# UNITED STATES PATENT AND TRADEMARK OFFICE

APPLICATION NO.	FILING DATE	FIRST NAMED INVENTOR	ATTORNEY DOCKET NO.	CONFIRMATION NO.
10/626,361	07/23/2003	Jeremy A. Davis	200210054-1	1224

<b>Office Action Summary</b>	<b>Application No.</b> 10/626,361	<b>Applicant(s)</b> DAVIS, JEREMY A.	
	<b>Examiner</b> William H. Rodriguez	<b>Art Unit</b> 3746

### **FINAL REJECTION**

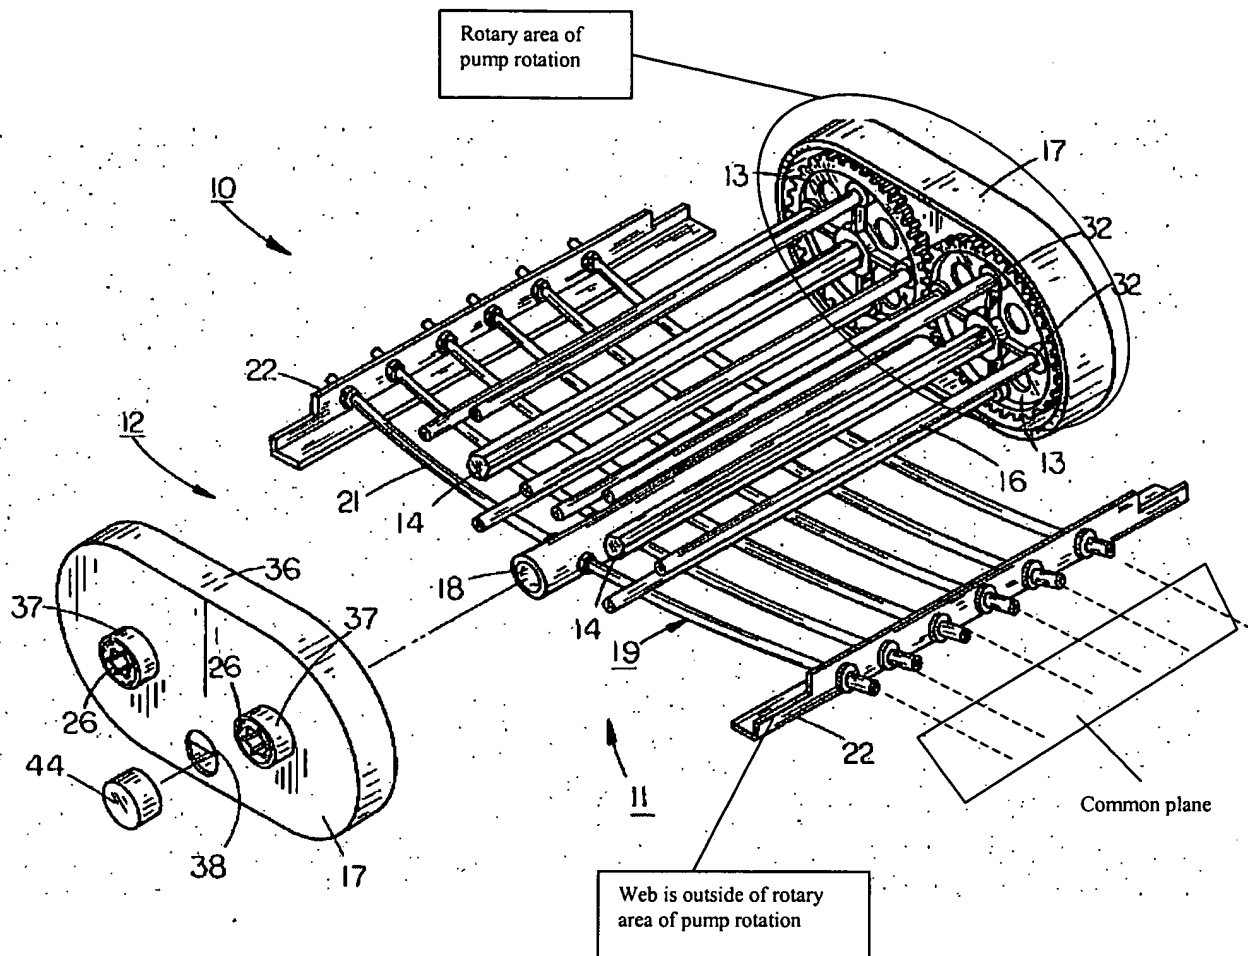
With respect to claims 1 and 19, **Schartz** teaches a pump having a rotary portion 16 which compels the movement of a fluid by peristaltic compression of resilient tubing 19 containing the fluid, a tube component comprising a plurality of adjacent resilient tubes; a web 22 interconnecting the adjacent resilient tubes, the resilient tubes has a cross-sectional centerline occurring in a common plane, and the web interconnects the resilient tubes in an area outside of the common plane, the rotary portion of the pump includes a rotary area of pump operation, and the web is outside the rotary area of pump operation. See particularly Figure above.

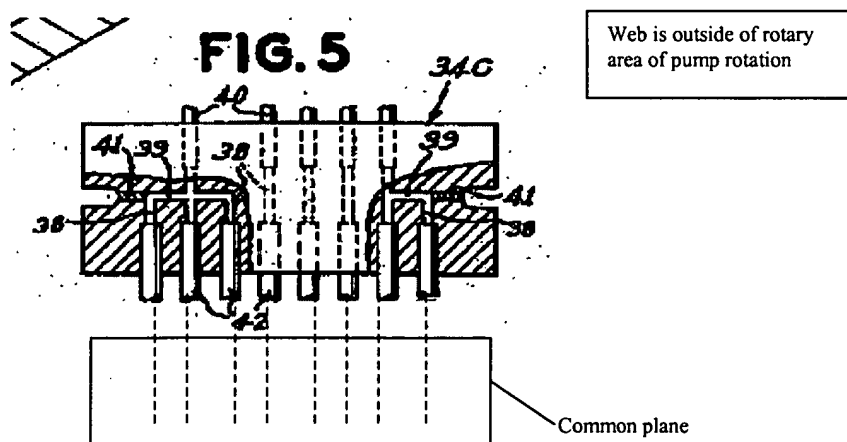
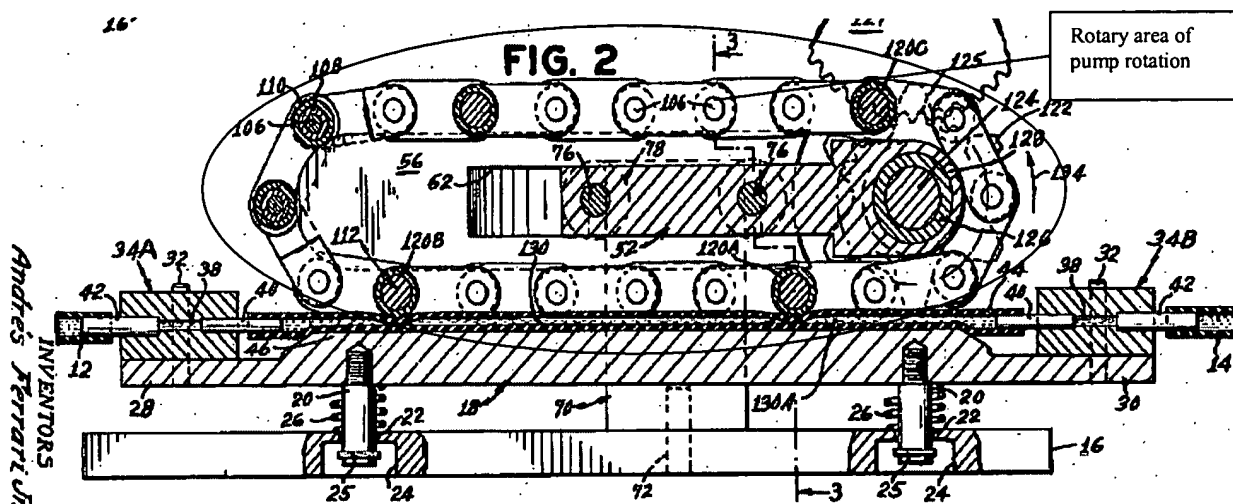
With respect to claim 1, **Ferrari** teaches a pump having a rotary portion 120 which compels the movement of a fluid by peristaltic compression of resilient tubing (44, 40, 42) containing the fluid, a tube component comprising a plurality of adjacent resilient tubes; a web 34C interconnecting the adjacent resilient tubes, the resilient tubes has a cross-sectional centerline occurring in a common plane, and the web interconnects the resilient tubes in an area outside of the common plane, the rotary portion of the pump includes a rotary area of pump operation, and the web is outside the rotary area of pump operation. See particularly **Figures 2, 5** above and column 4 lines 59-71 of **Ferrari**.

With respect to claim 13, **Ferrari** teaches a method of assembling a pump having a rotary portion 120 which compels the movement of a fluid by peristaltic compression of resilient tubing (40, 42, 44) containing the fluid comprising the following: providing a plurality of adjacent resilient tubes, and interconnecting the adjacent resilient tubes with a web 34C, providing a plurality of adjacent resilient tubes comprises providing each of the resilient tubes with a cross-sectional centerline occurring in a common plane, and interconnecting the adjacent resilient tubes with a web comprises interconnecting the resilient tubes in an area outside of the common plane, the rotary portion of the pump includes a rotary area of pump operation, and interconnecting the adjacent resilient tubes with a web comprises interconnecting the resilient

tubes in an area outside the rotary area of pump operation. See particularly **Figures 2, 5** above and column 4 lines 59-71 of Ferrari.
